Well Name: CORRAL 23-26 FED COM	Well Location: T25S / R29E / SEC 23 / SENW / 32.118163 / -103.957804	County or Parish/State: EDDY / NM
Well Number: 210H	Type of Well: OIL WELL	Allottee or Tribe Name:
Lease Number: NMNM120895	Unit or CA Name:	Unit or CA Number:
US Well Number: 3001556888	Operator: XTO ENERGY INCORPORATED

Notice of Intent

Type of Submission: Notice of Intent	Type of Action: APD Change
Date Sundry Submitted: 07/08/2025	Time Sundry Submitted: 02:55
Date proposed operation will begin: 07/15/2025

Procedure Description: XTO Energy Inc. respectfully requests approval to make the following changes to the approved APD. Changes include KOP, FTP, LTP, BHL, Proposed total depth, Pool, and dedicated acreage, Formation TVD, Casing Design, Cementing Program, Mud Program. APD ID 10400098943; Well API: 30-015-56888 FROM: TO: KOP: 1673' FNL & 1831' FWL OF SECTION 23-T25S-R29E 330' FNL & 1960' FWL OF SECTION 23-T25S-R29E FTP: 100' FNL & 1980' FWL OF SECTION 23-T25S-R29E 330' FNL & 1960' FWL OF SECTION 23-T25S-R29E LTP: 100' FSL & 1980' FWL OF SECTION 35-T25S-R29E 330' FSL & 1960' FWL OF SECTION 26-T25S-R29E BHL: 50' FSL & 1980' FWL OF SECTION 35-T25S-R29E 50' FSL & 1960' FWL OF SEC

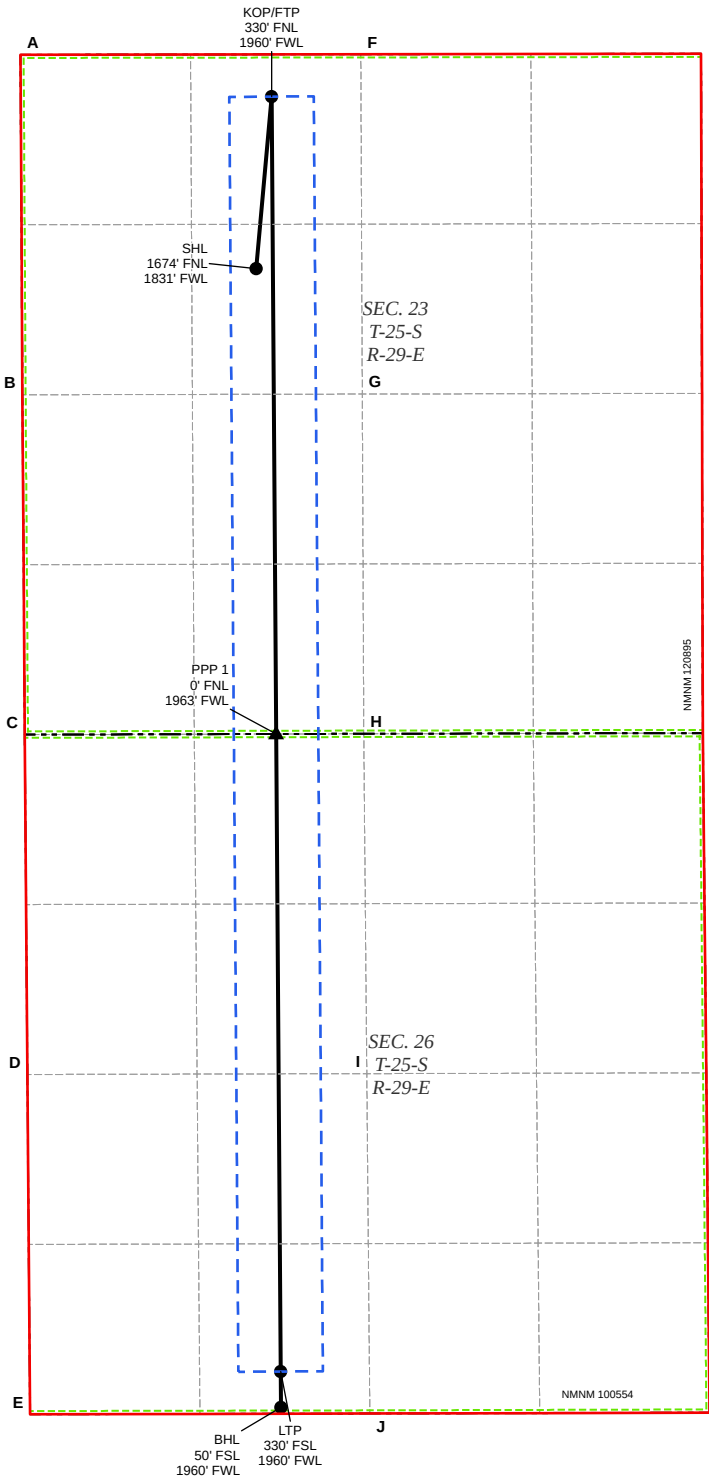
KOP: 1673' FNL & 1831' FWL OF SECTION 23-T25S-R29E 330' FNL & 1960' FWL OF SECTION 23-T25S-R29E
FTP: 100' FNL & 1980' FWL OF SECTION 23-T25S-R29E 330' FNL & 1960' FWL OF SECTION 23-T25S-R29E
LTP: 100' FSL & 1980' FWL OF SECTION 35-T25S-R29E 330' FSL & 1960' FWL OF SECTION 26-T25S-R29E
BHL: 50' FSL & 1980' FWL OF SECTION 35-T25S-R29E 50' FSL & 1960' FWL OF SECTION 26-T25S-R29E

The proposed total depth is changing from 24939 MD; 8072 TVD to 20511 MD; 10358 TVD
Continued on page 3 additional information

The Dedicated acreage is changing from 640 to 1280.

Offline Cementing Procedure

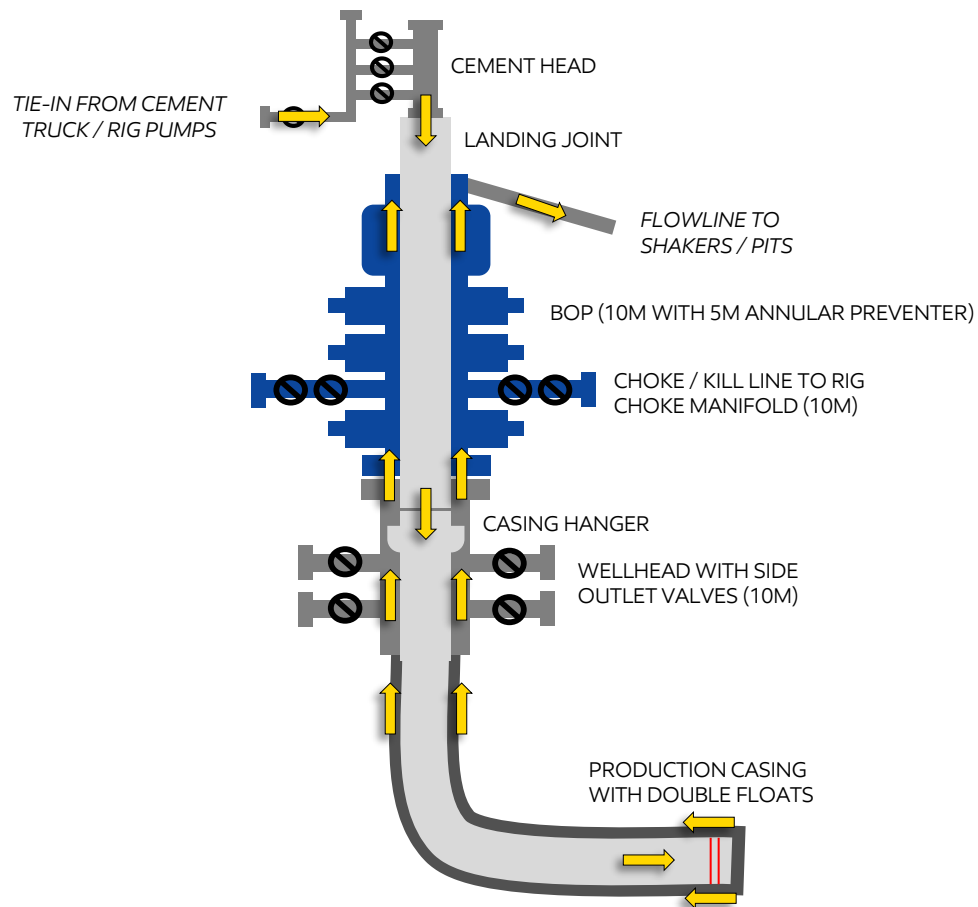
The following conditions must be met to proceed with offline production cementing on Wolfcamp target formations or shallower:

- a) *Casing hanger successfully landed in the wellhead*
- b) *Ability to circulate overbalanced mud weight*
- c) *Initiate offline cementing operations within 24hr of landing casing*
- d) *All well control barriers test successfully and BLM notified of intent to perform offline production cementing prior to N/D BOP*
- e) *No offset frac operations within 1 mile and within the same target horizon*
- f) *Well Control certified ExxonMobil Operations Supervisor to be present during offline cementing operation to monitor returns*
- g) *Drill ahead operations will not begin on next well until offline production cement operations have concluded*

KEY DIFFERENCES

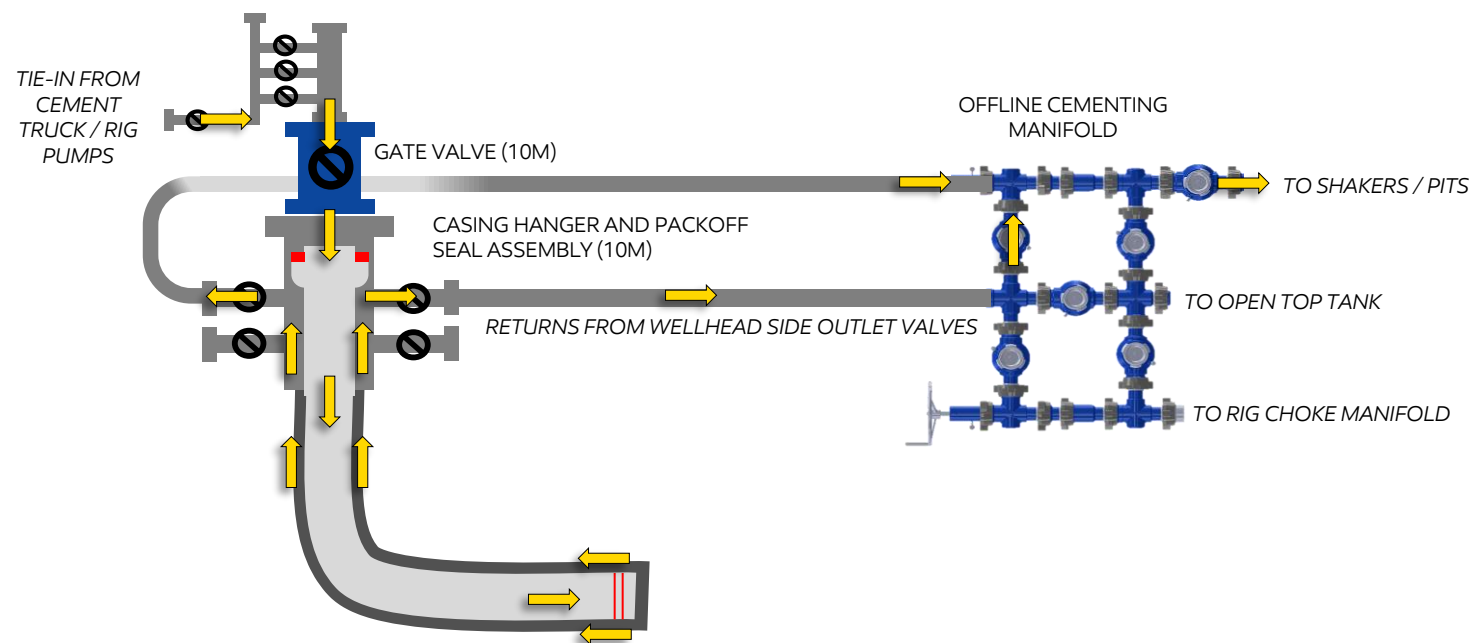
1. Rig BOP replaced by gate valve and WH adaptor assembly (10M rated)
2. Addition of offline cementing manifold and high pressure iron to direct fluid returns to rig active system and/or choke manifold
3. Packoff annulus barrier in place and tested prior to cementing operations (10M rated)
4. Cement truck performs cement job displacement (vs rig pumps)
